**REDLINE**

## **Teanaway Solar Reserve**

# **Conditional Use Permit Application Supplement and Expanded SEPA Checklist Supplement**

**FEBRUARY 2010**

**FIGURE 3**  
**Site Access Map**  
Teanaway Solar Reserve  
Kittitas County, Washington

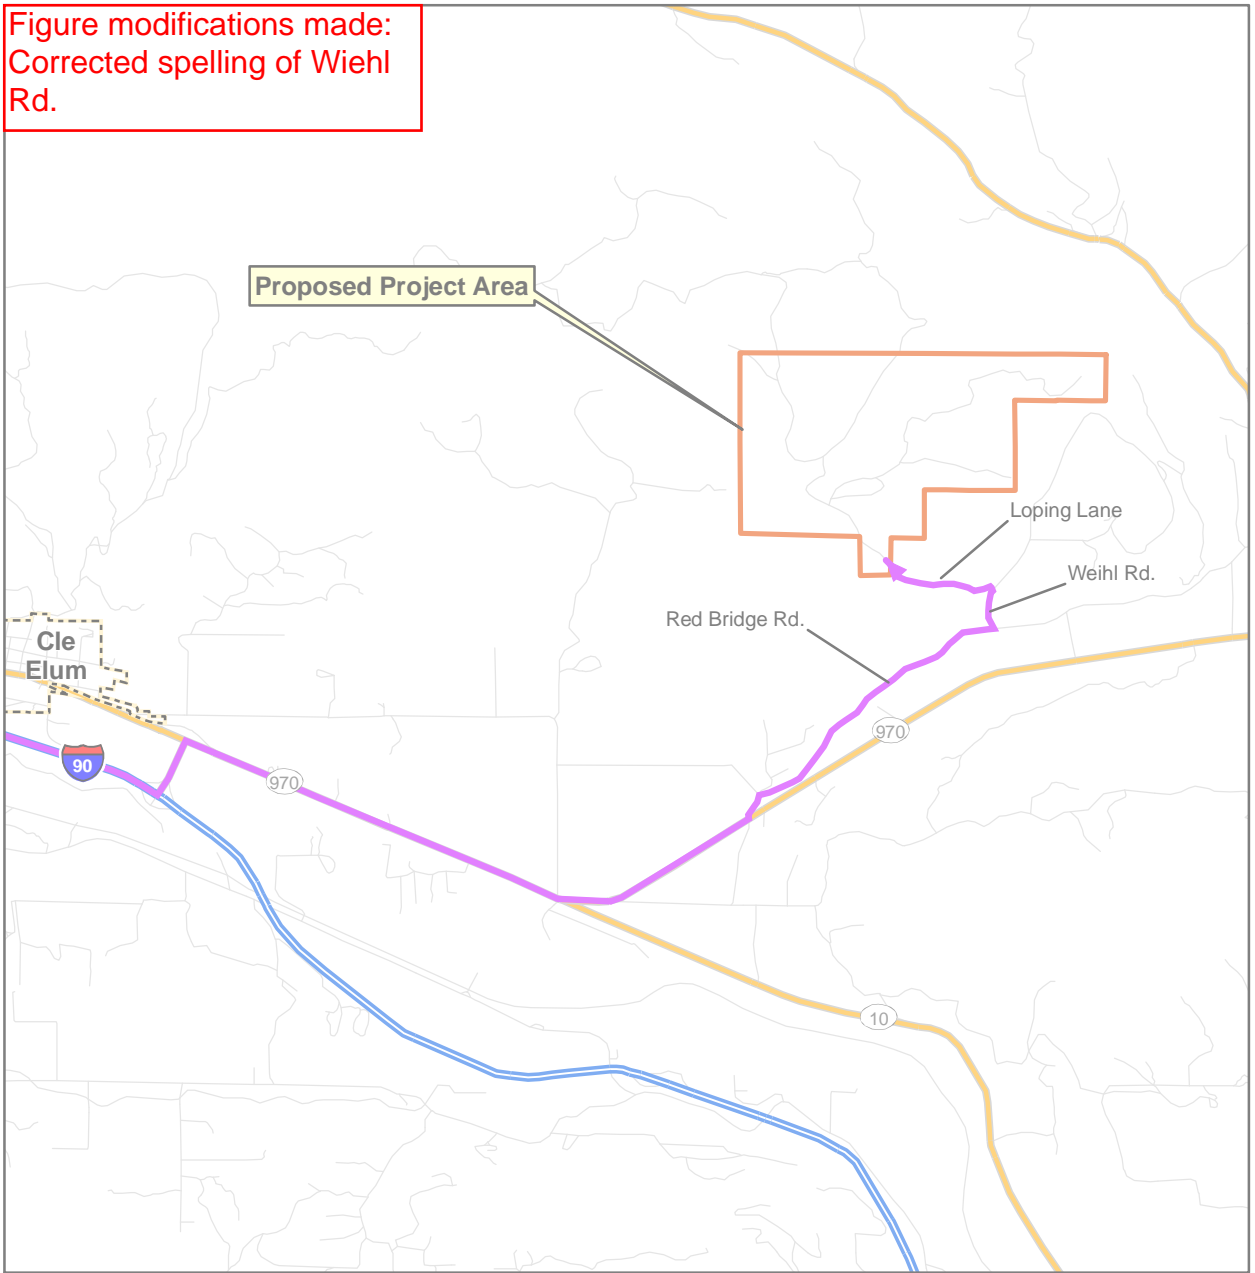
Figure modifications made:  
Corrected spelling of Wiehl Rd.

**FIGURE 4**  
**Identified Structure Map**  
 Teanaway Solar Reserve  
 Kittitas County, Washington

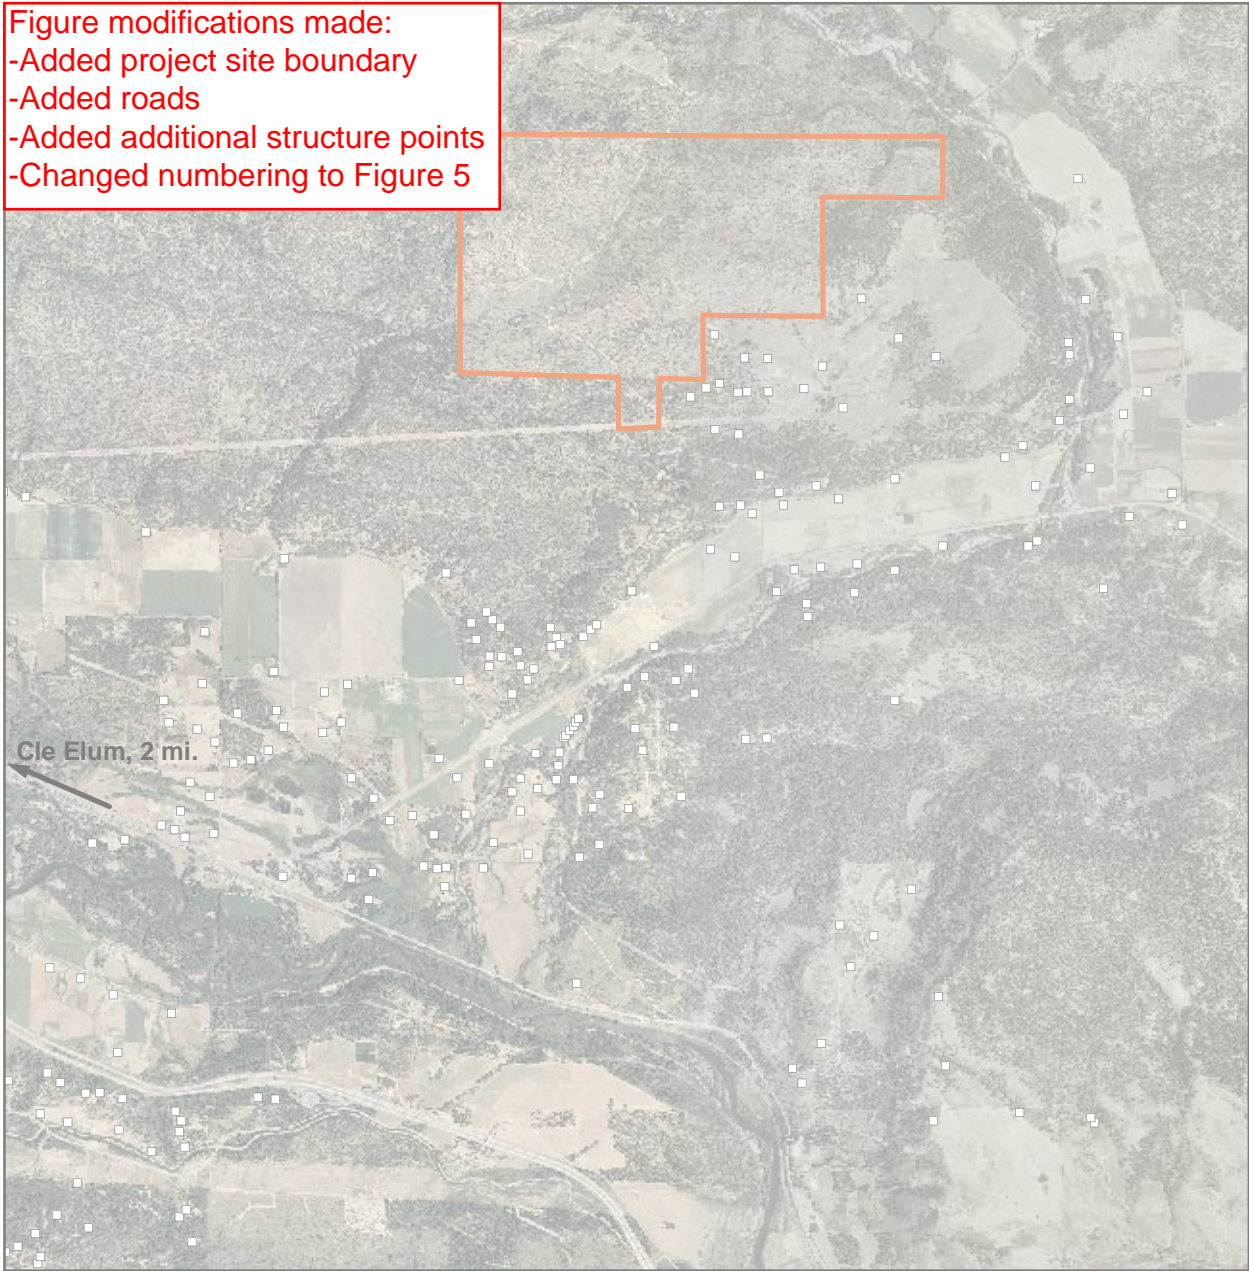
Figure modifications made:  
 -Added project site boundary  
 -Added roads  
 -Added additional structure points  
 -Changed numbering to Figure 5

**FIGURE 5**  
**Conceptual Site Layout**  
 Teanaway Solar Reserve  
 Kittitas County, Washington

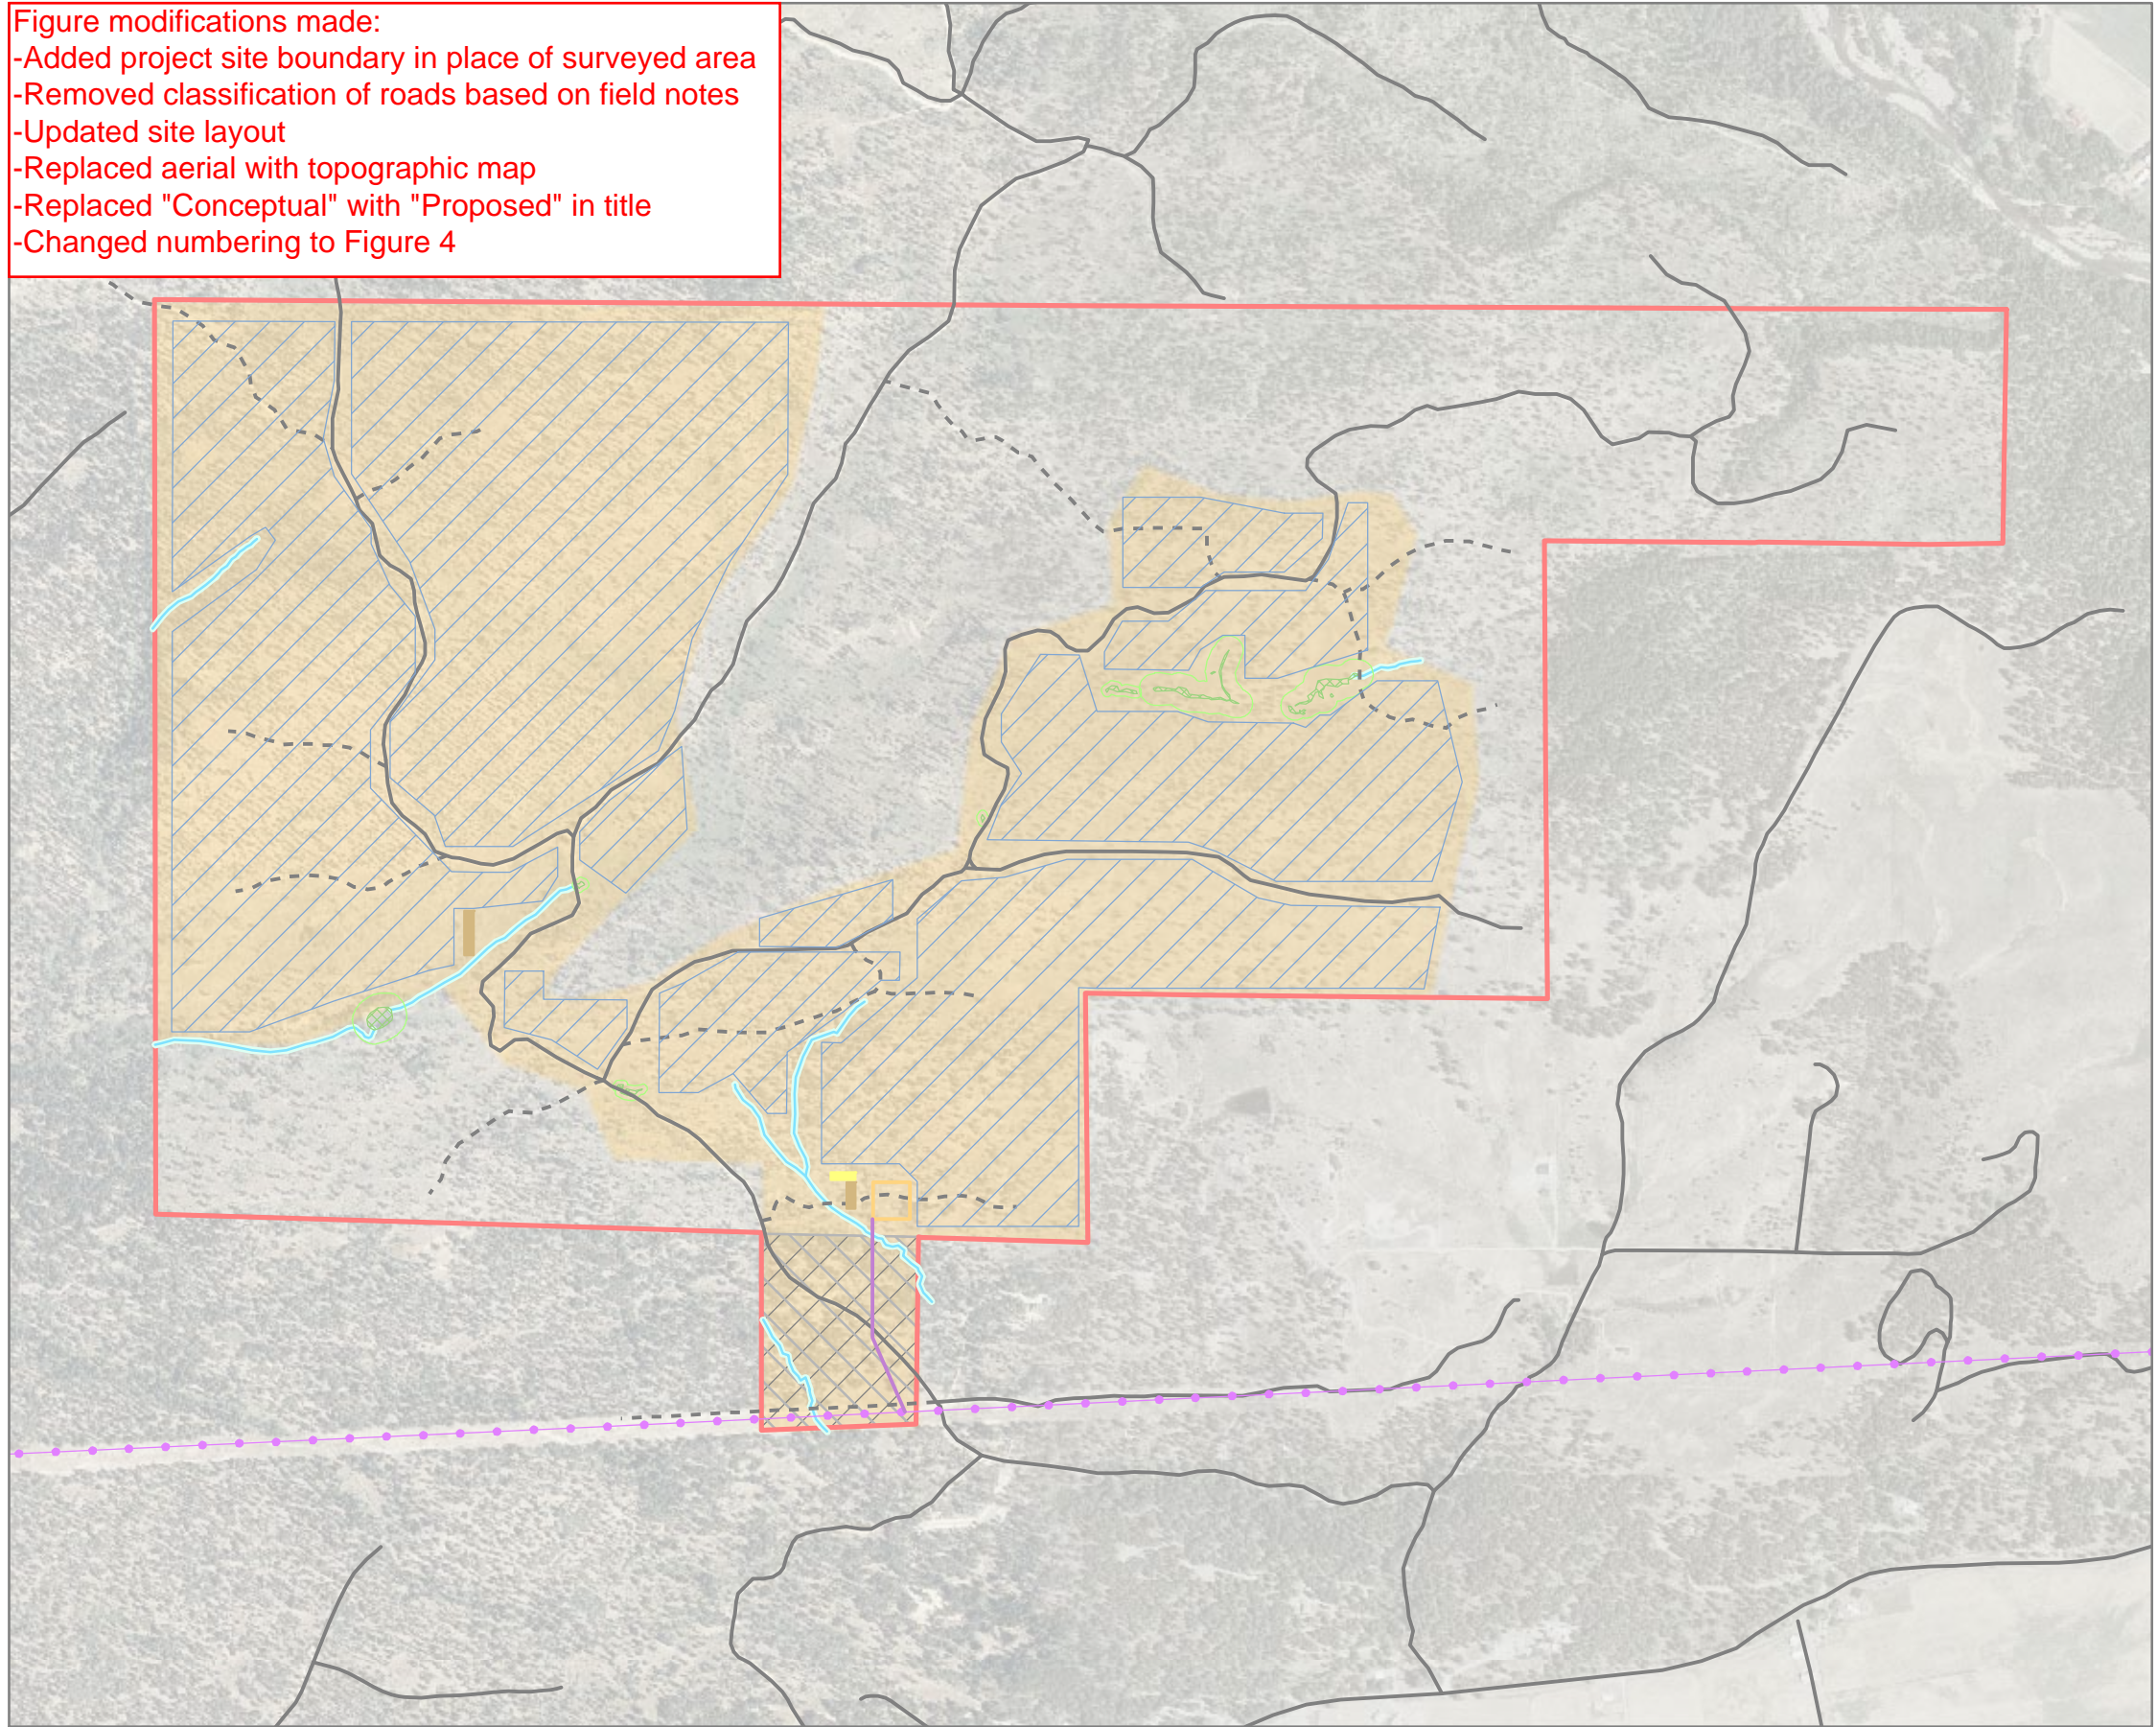
Figure modifications made:  
 -Added project site boundary in place of surveyed area  
 -Removed classification of roads based on field notes  
 -Updated site layout  
 -Replaced aerial with topographic map  
 -Replaced "Conceptual" with "Proposed" in title  
 -Changed numbering to Figure 4

**FIGURE 8**  
**Designated Critical Areas:**  
**Aquifer Recharge Areas**  
 Teanaway Solar Reserve  
 Kittitas County, Washington

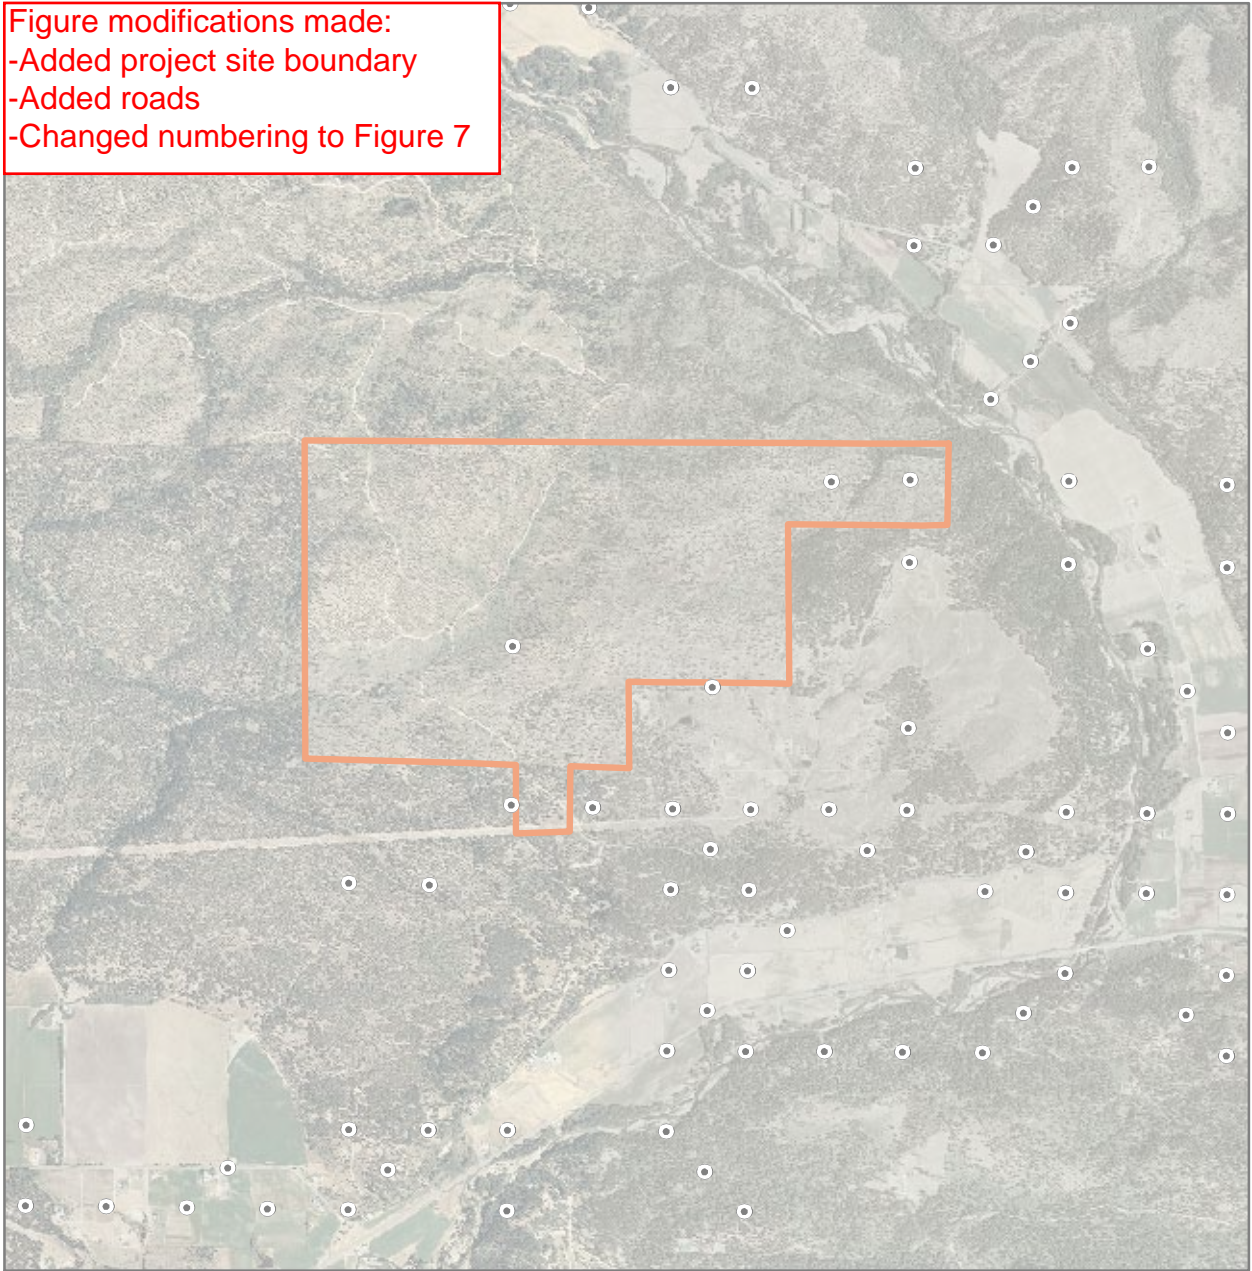
Figure modifications made:  
 -Added project site boundary  
 -Added roads  
 -Changed numbering to Figure 7

**FIGURE 9**  
**Designated Critical Areas: FEMA Federal Insurance Rate Map for Kittitas County**  
 Teanaway Solar Reserve  
 Kittitas County, Washington

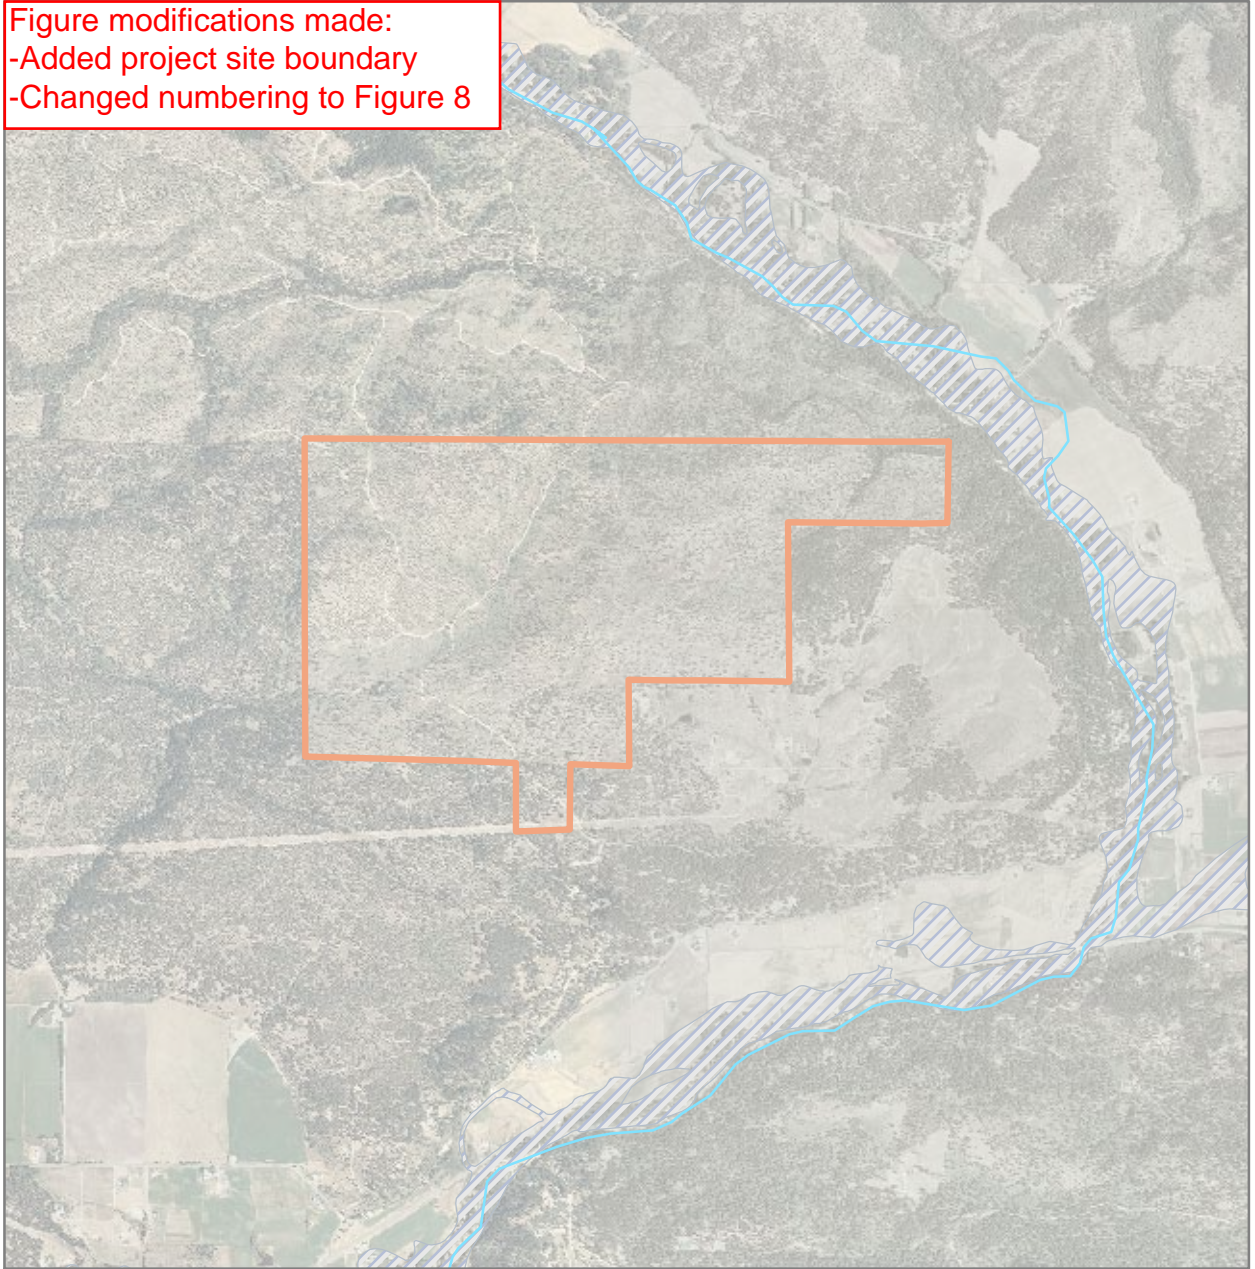
Figure modifications made:  
 -Added project site boundary  
 -Changed numbering to Figure 8
